CITY OF ALBUQUERQUE

RE: **4936 Pan American
Grading and Drainage Plan
Onsite Engineer's Stamp Date: 12/6/2017
Offsite Engineers Stamp Date: 12/12/2017
Hydrology File: F17D032**

Based upon the information provided in your submittal received 12/12/17, the Grading and Drainage Plan is approved for Preliminary Plat and Work Order.

DATE: 12/6/2017
SCALE: AS NOTED
SHEET: C1.3
2

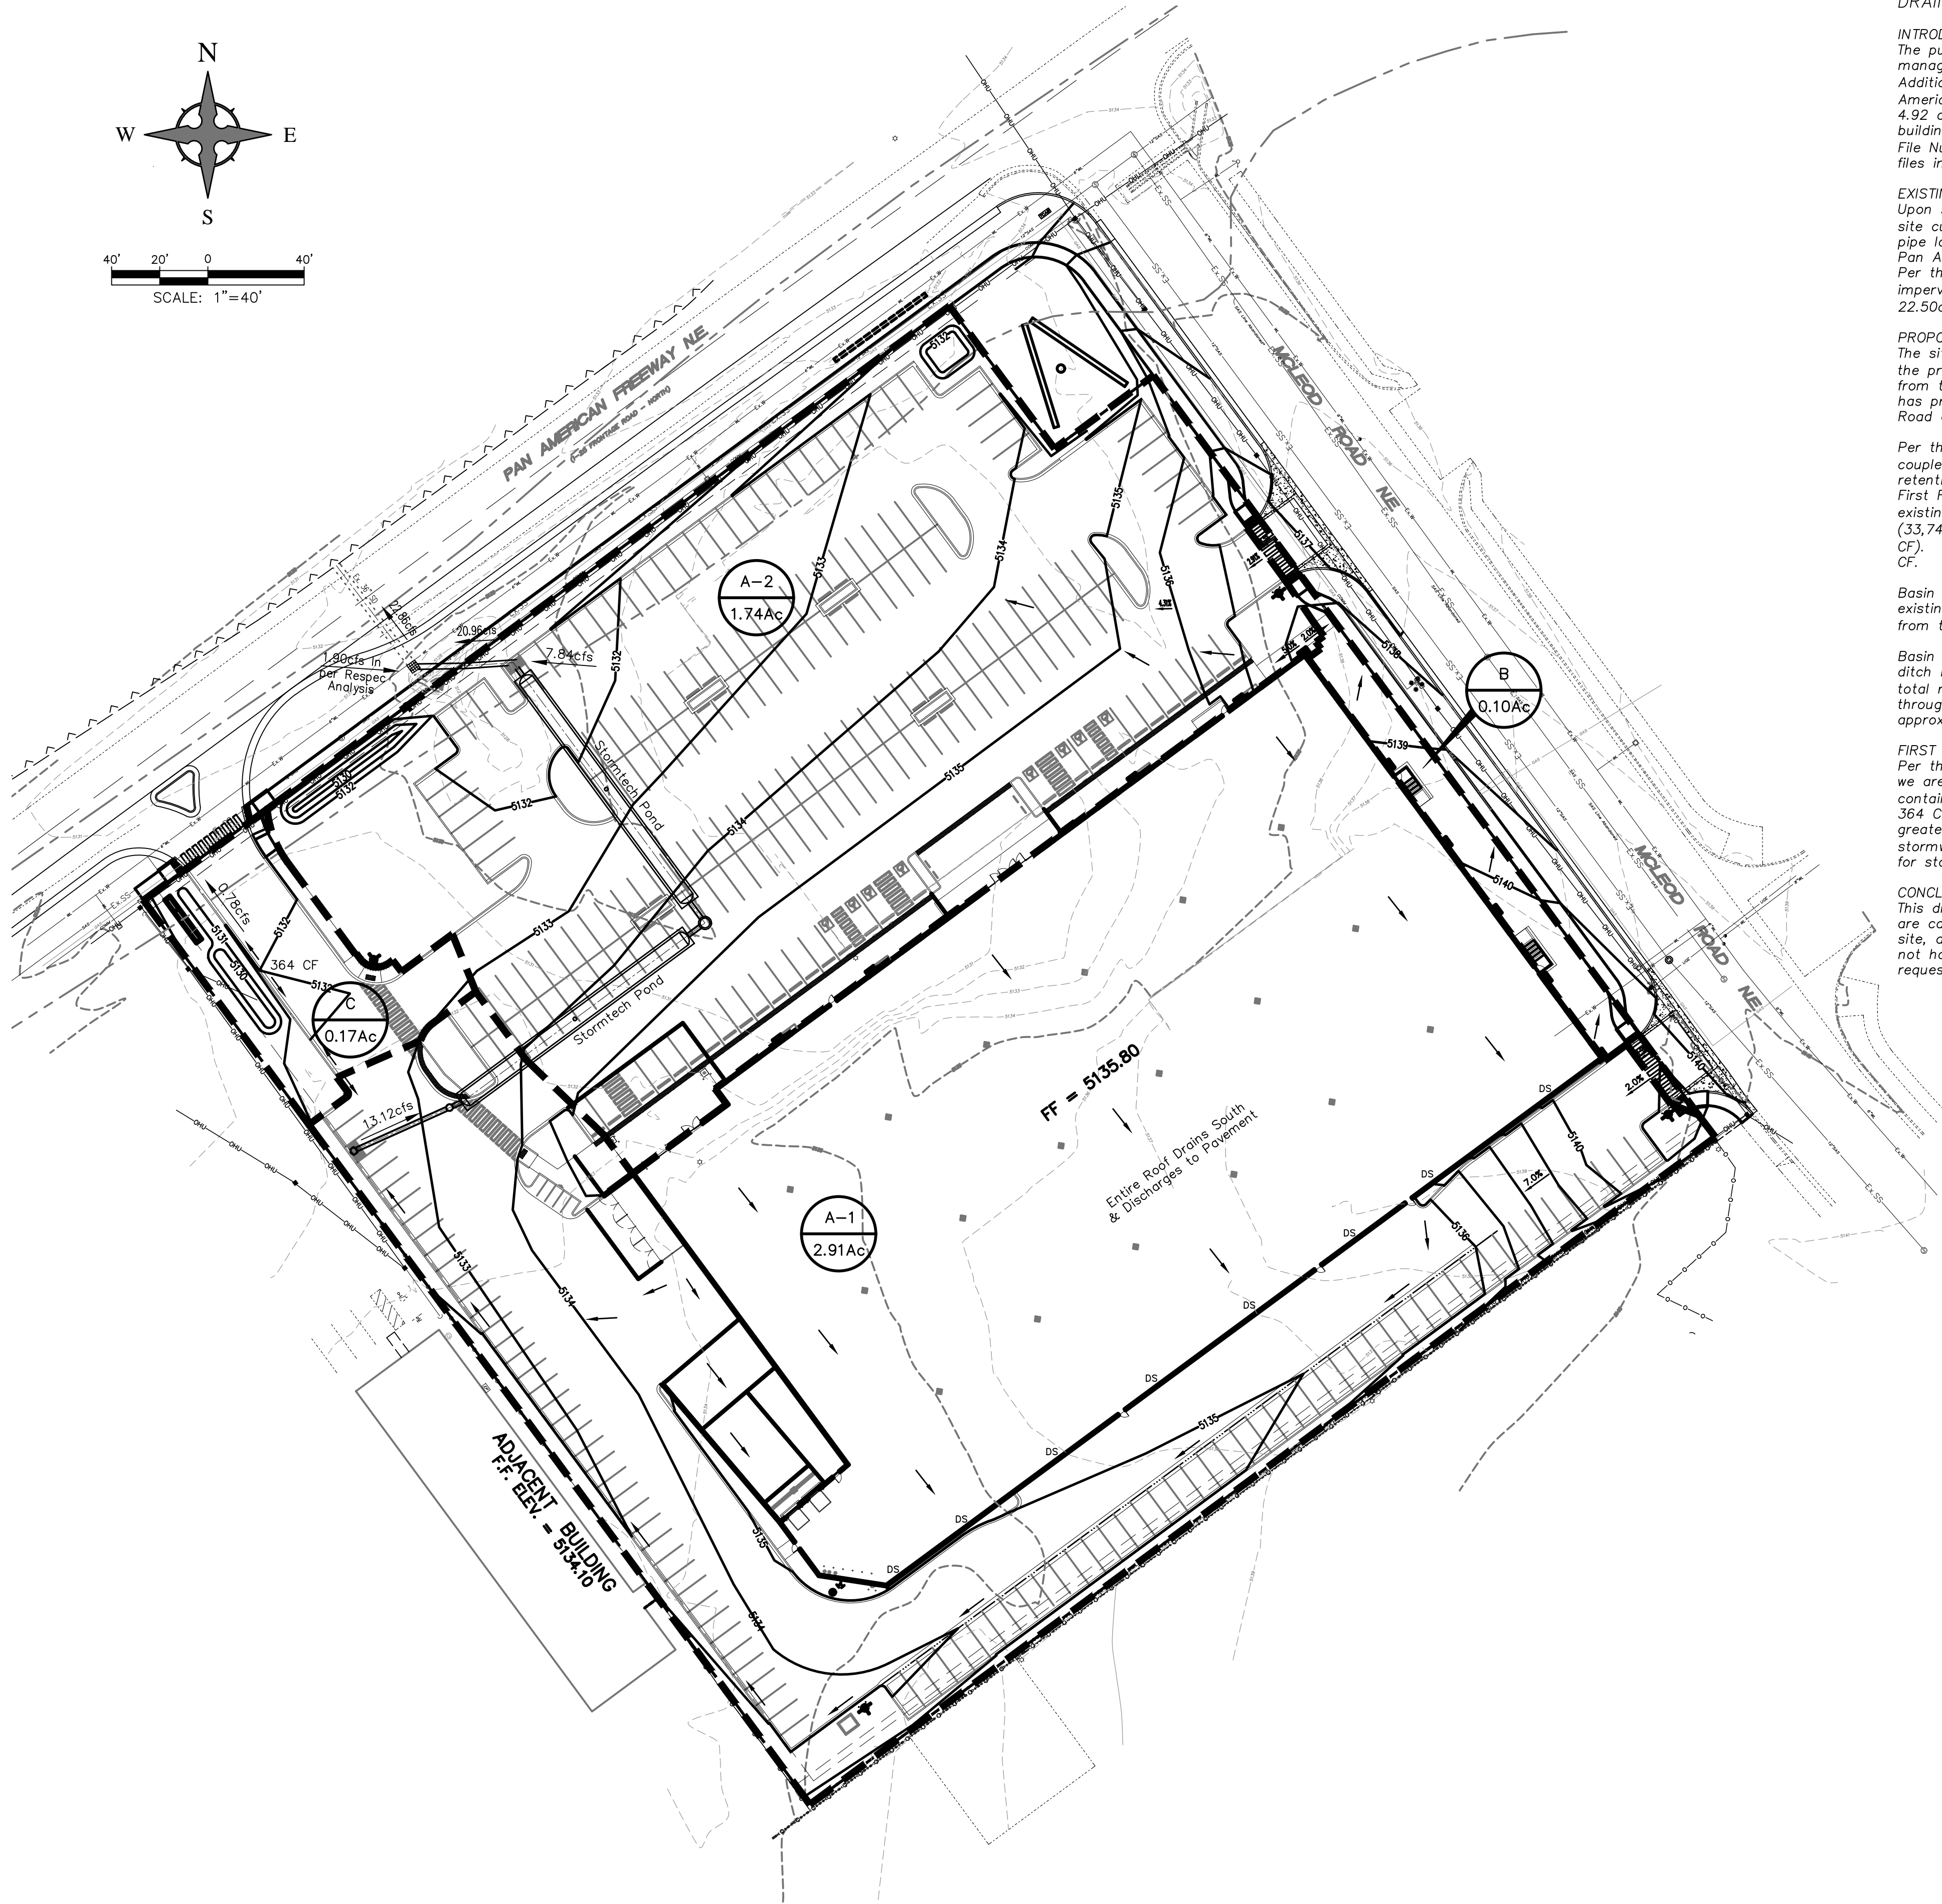
1. The site must be platted.
2. Payment of the Fee-in-Lieu is required for the first flush bypass volume (51CF x \$8.00/CF, per sheet C1.3 of the onsite plan).
3. A Private Facility Drainage Covenant is required for the stormwater quality ponds/stormtechs. The original notarized forms, exhibits, and recording fee (\$25, payable to City of Albuquerque) must be turned into DRC (4th, Plaza del Sol) for routing. Please contact Charlotte LaBadie (clabadie@cabq.gov, 924-3996) or Madeline Carruthers (mtafoya@cabq.gov, 924-3997) regarding the routing and recording process for covenants.
4. Provide the Approved NMDOT Permit for construction along the frontage road.
